Structural Plan Check Response

To: Mike Olsen
City of Portland
From: Michael Archer P.E.
Archer Engineering
Regarding: Application # 04-001465-REV-01-RS
Foundation Anchor
Lipset / More Residence
3127 NE Tillamook St. Portland, OR
Date: August 5, 2005

PARTIAL FOUNDATION PLAN

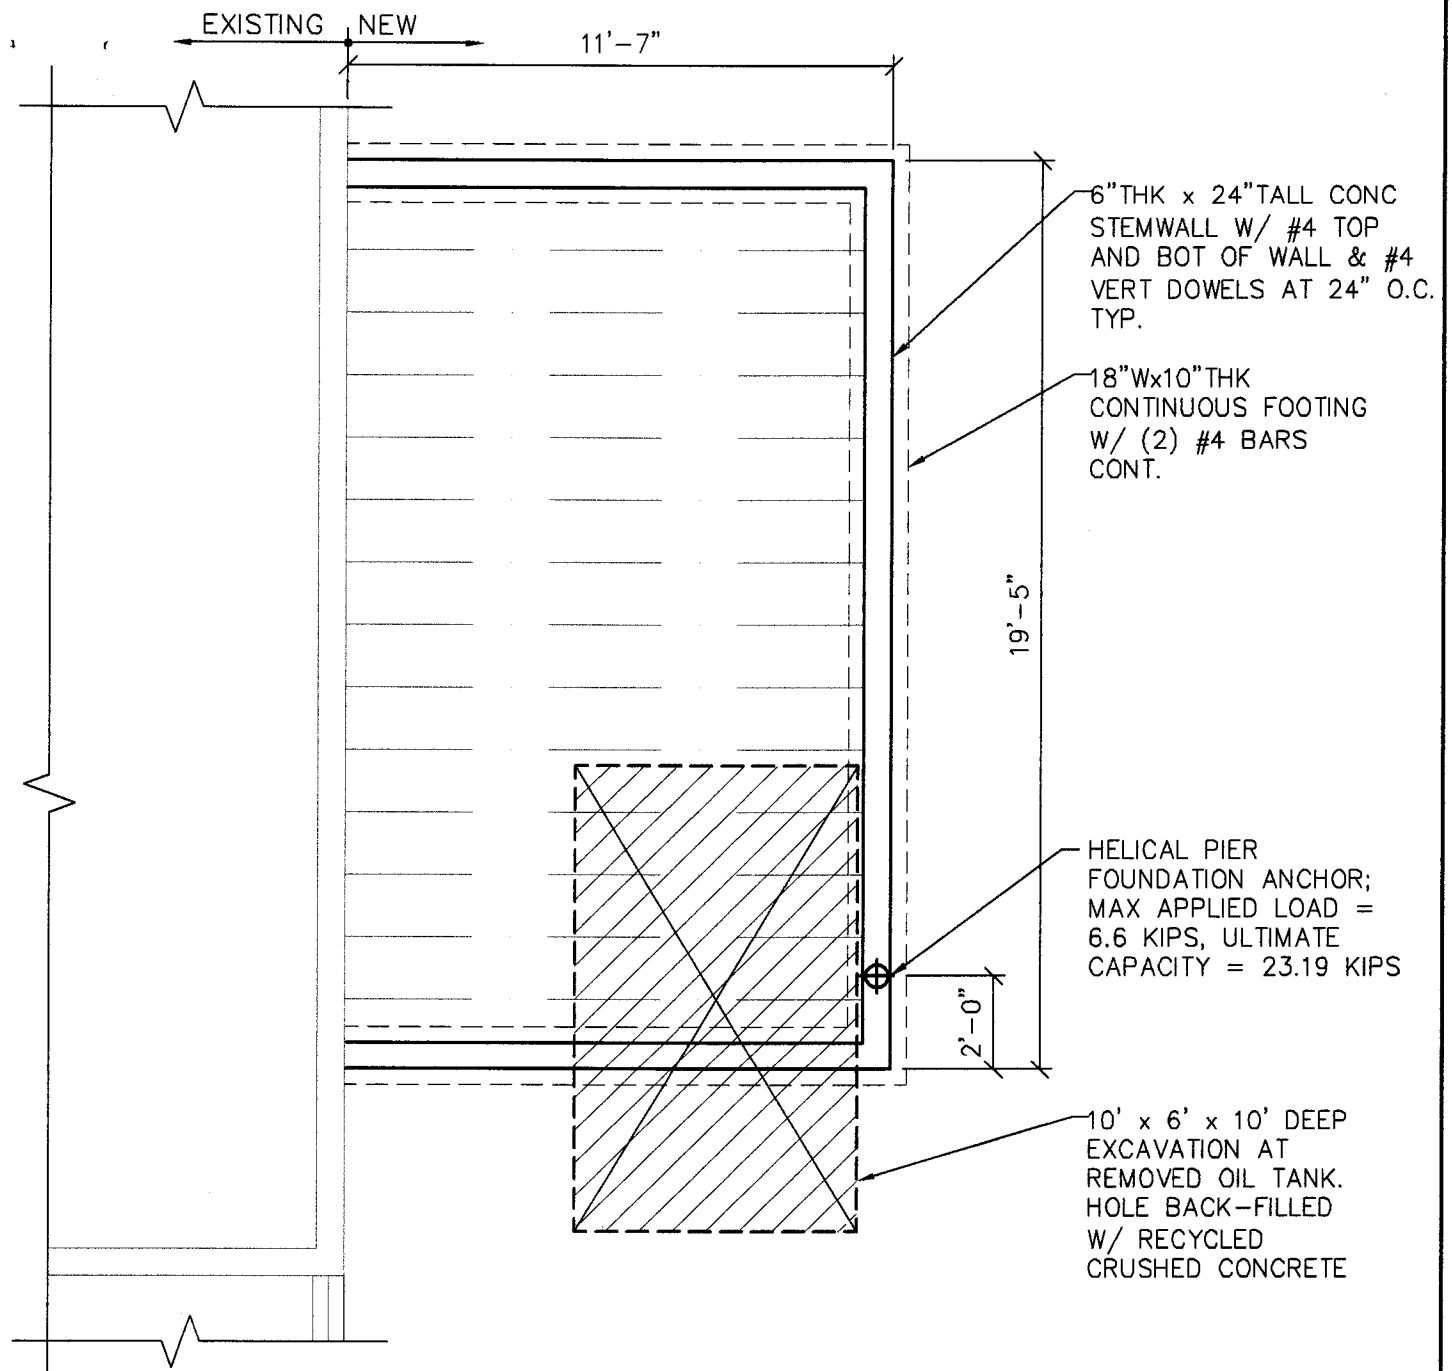
Item #	Issue	Response
1.	Anchor part #	Lead Section # C150-0007; Extension # C150-0008. Anchor manufacturer: <i>Chance</i> . See enclosed anchor drawings.
2.	Anchor installation specifications	Enclosed.
3.	Minimum tip elevation	Minimum elevation was 15'; actual tip elevation was 30'.
4.	Load calculations	Enclosed. Factor of Safety = 3.5
5.	Testing procedure	Enclosed. Testing the anchor should not be required.
6.	Discussion of differential settlement	The settlement of the anchor and the surrounding native soil that supports the foundation should both be negligible.
7.	Special Inspection	Inspection Report from Carlson Testing enclosed.
